UNIVAIR MANDATORY SERVICE BULLETIN LPC-1: Amend. A
Supercedes Service Bulletin LPC-1, Dated October 24, 1995
DATE: SEPTEMBER 17, 2004

SUBJECT: Mandatory Landing Gear Product Improvement

APPLICABILITY: Piper PA-22 aircraft modified to taildragger configuration using STC-SA45RM.

View Looking Aft
Right Hand Gear Shown

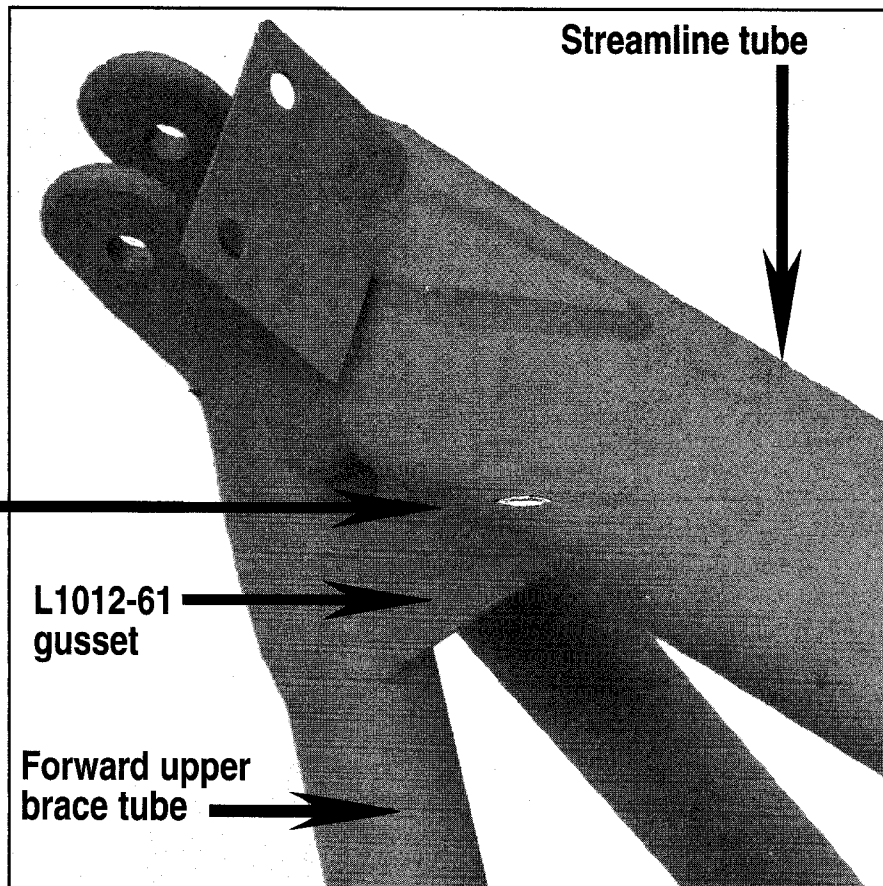
Weld Approximately
1/16" - 1/8" from edge
of streamline tube.

L1012-61
gusset

Forward upper
brace tube

End View
Right Hand
Gear Shown

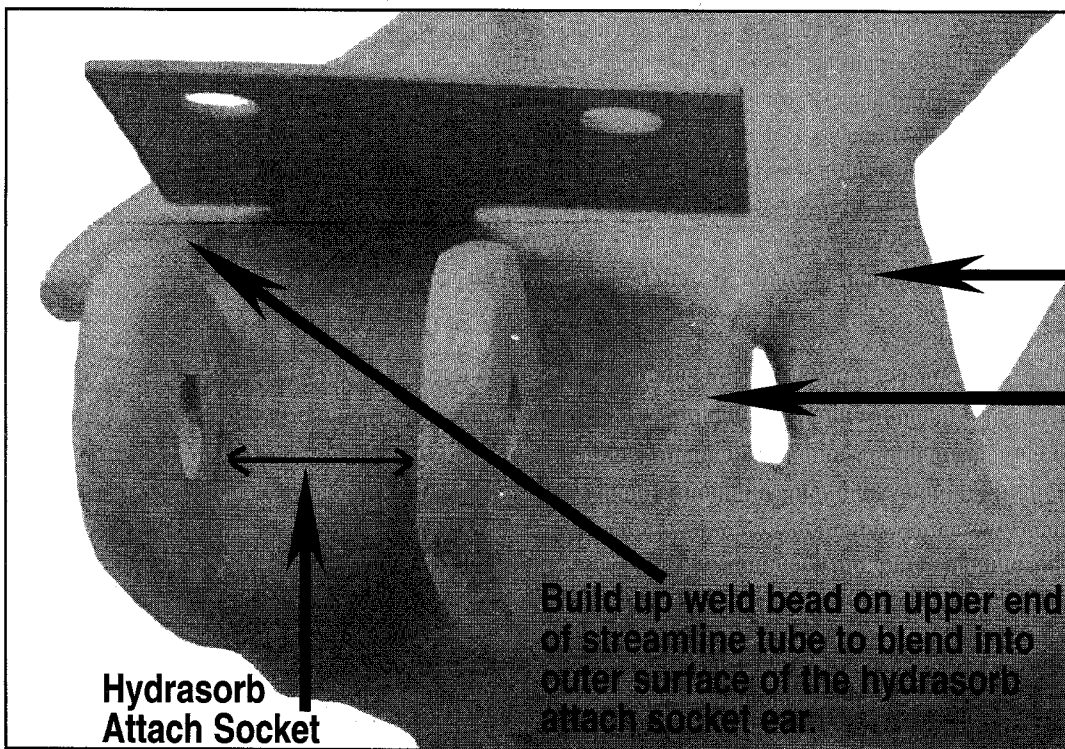
L1012-61
gusset

Extend this weld bead
as far as
possible between
streamline tube
and forward upper
brace tube.

Build up weld bead on upper end
of streamline tube to blend into
outer surface of the hydrasorb
attach socket ear.
